## ADDENDUM NO. 1

Project: **MAINT 2023-0001 – SPORTSPLEX DR**

Owner: **City of Dripping Springs, Texas**

Date: **May 12<sup>th</sup>, 2023**

SHEET TITLE:  
PAVING DETAILS

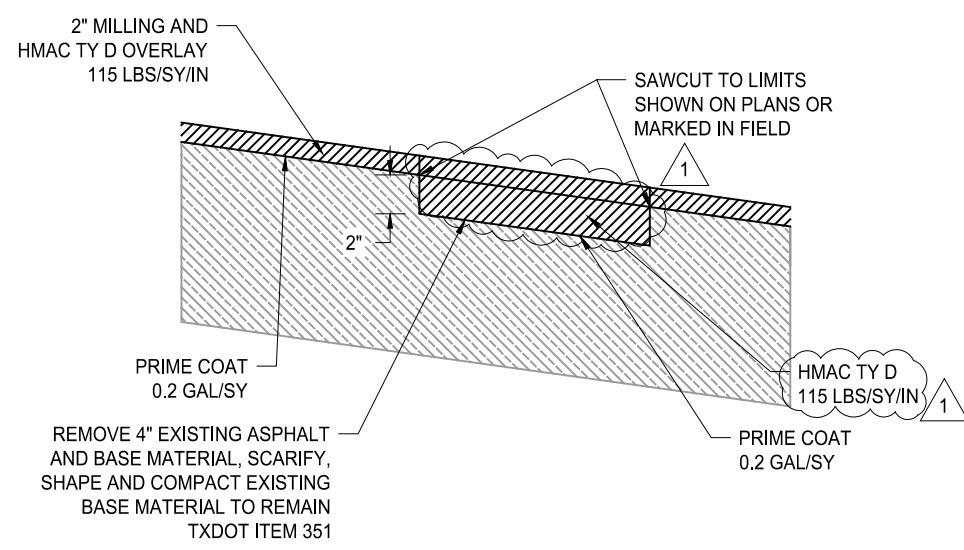
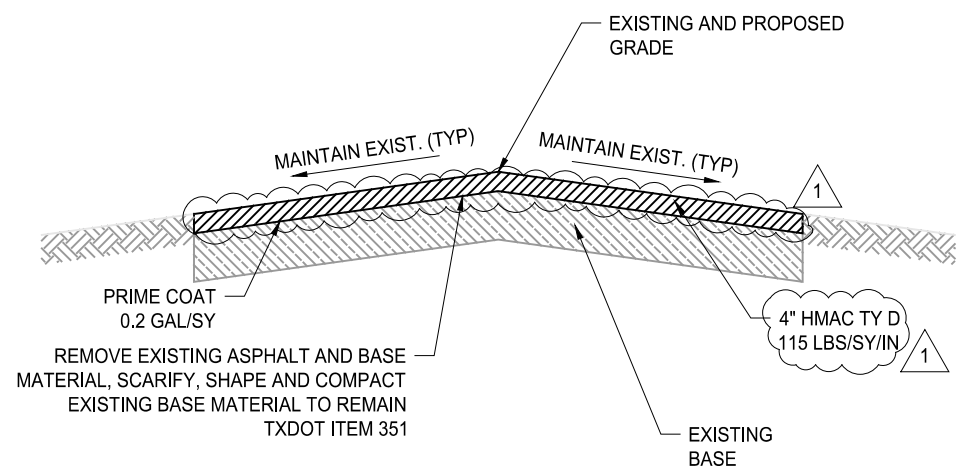
- Question:* TXDOT Spec for the Minimum Thickness of TY B is 2.5" due to the Size of Aggregate in the mix, this is calling for 2" on Base Bid & Add Alt 1.  
*Response:* HMAC TY B has been removed from the plans and bid form. Please see attached revised bid documents.

Sheet 7 of 18 – PAVING DETAILS

REPLACE – Sheet with the attached version.
